# T E R R A   B E L L A   L A N D   D E S I G N

To: Seamus O'Rourke, Chairman      From: Terra Bella Land Design  
Company: Village of Mamaroneck Planning Board      Contact Name: Susan Oakley  
eMail: sorourke@vomny.net      Page #: 1 of 2  
Subject: **921 Soundview Drive**      Date: **January 31, 2023**

The updated plans for the proposed, single family residence at 921 Soundview Drive have been reviewed. This memo addresses comments made in the previous Terra Bella Land Design memo, dated January 6, 2023, and how the applicant has responded in their most recent submissions.

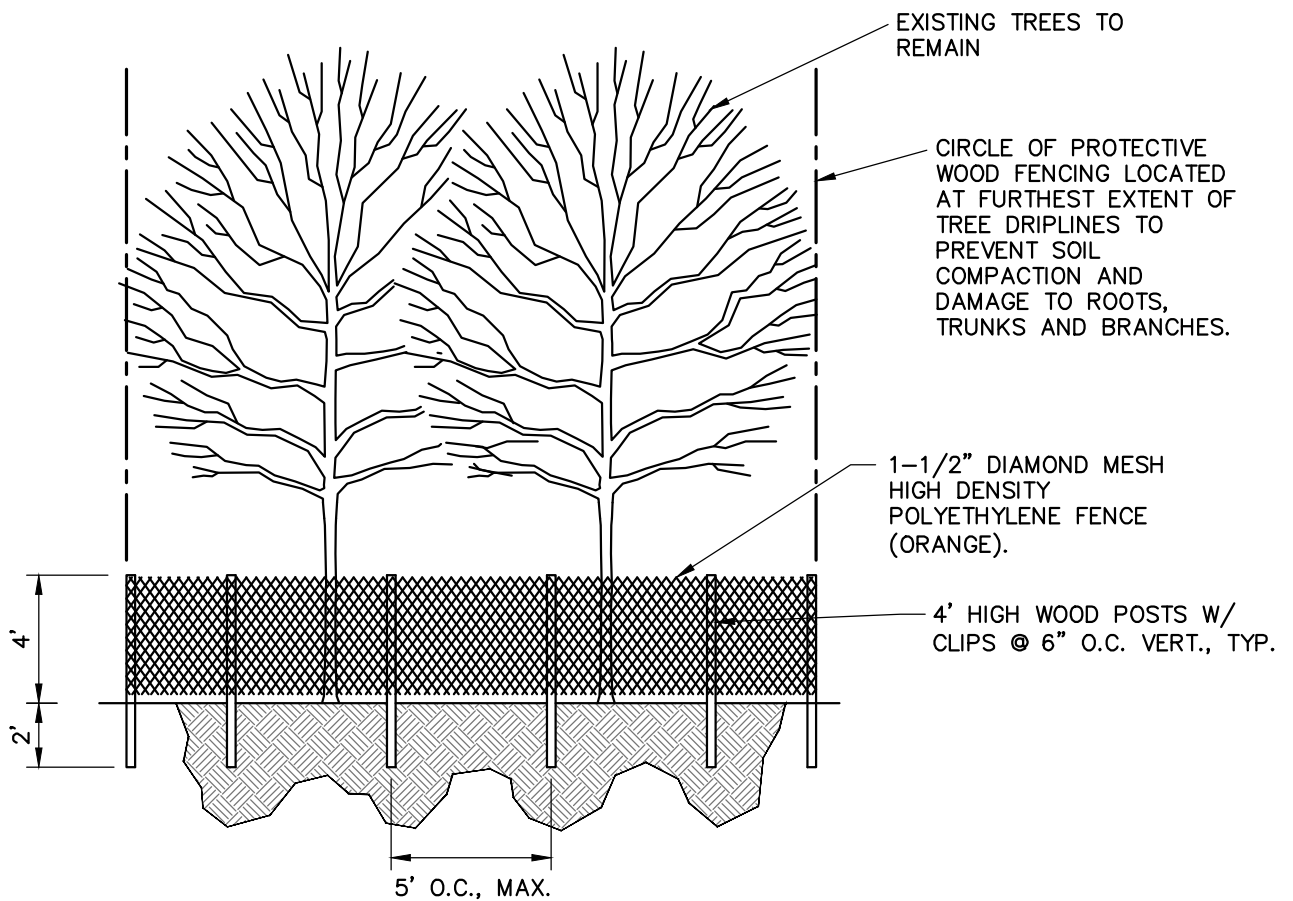
Comment (continued): ...(T)here are many existing trees on the property, and on adjacent properties, that need preserving. Therefore, a Tree Preservation Plan is required as part of the application.

*Therefore, all trees on adjoining lots that have roots and/or canopies that fall under and/or over these property lines also need protection and to be shown on the plans listed below. A tree protection detail is provided on ALP Engineering's Construction Details (C-111), but does not contain all the information on the Village's Tree Protection Standard.*

*Since tree protection is most effective when installed before any construction begins, it also needs to be present on the following drawings: ALP Engineering's Site Layout Plan (C-101), Grading and Utilities Plan (C-102), and their Erosion and Sediment Control Plan (C-103). Tree protection is not necessary on Nexus Lighting Plan (E1).*
